Technical Note TN-722

Control Head Changes for the T2035

19th July 2002

This Technical Note only applies to the T2035 trunking radio.

Service Note Requires Pgm V1.60 or later See TN722 for more detail
--

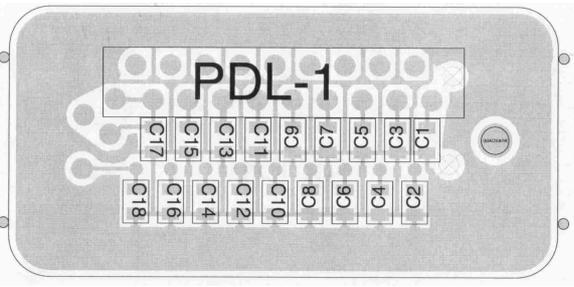
Radios with the new control head will be identified with a sticker on the underneath of the control head. This sticker will have information regarding minimum Pgm version needed and the identity of this Technical Note.
